Abstract

To ensure operating without inconvenience of the 1st series of lamp heads with the lithium battery pack, you need to upgrade the head board inside the head body by following the below instructions.

50.0044.02 compatible with Li-ion batt.
50.0044.03 compatible with Li-ion (future series)

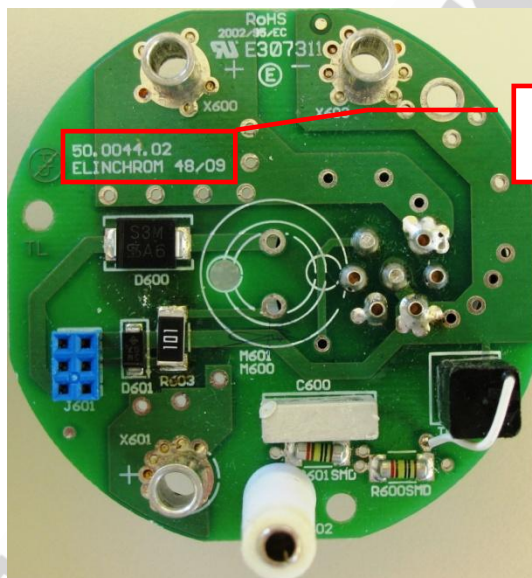
1. Disconnect the lamp head from the power pack by removing the cable
2. Remove the flashtube from the body head. Have a look with a spot light (pocket lamp is well suited) through the flashtube holes to check the marking on the flashboard inside.
 - a. for S-lamps
 - i. if you see through the left hole the marking “50.0044.02” or “50.0044.03”, the lamp head is fully compatible → no upgrade, go to point 6.

- ii. if you do not see through the left hole any marking “50.0044.02” or “50.0044.03”, the lamp head is of 1st series → upgrade is necessary, go to point 3.

50.0044.01 not compatible with Li-ion

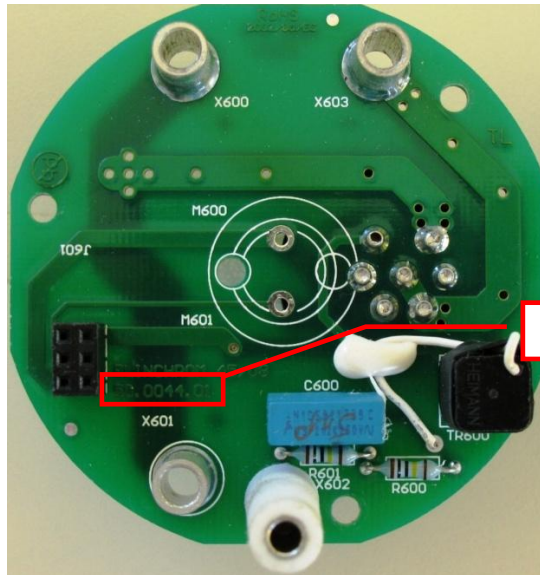
- i. if you do not see through the bottom left hole any marking, the lamp head is fully compatible → no upgrade, go to point 6.
- ii. if you see through the bottom left hole the marking “50.0044.01”, the lamp head is of 1st series → upgrade is necessary, go to point 3.

3. Unscrew the 3 screws holding the inner reflector with LED and remove the reflector
4. Unscrew the 3 screws holding the board of version **01** (50.0044.**01**) in the bottom of the head body
5. Mount the board of the version **02** (50.0044.**02**) or higher by re-screwing the 3 screws (same board for S-head or A-head)
6. Re-assemble the inner reflector by tightening the 3 screws and re-plug the flashtube with the trigger contact.
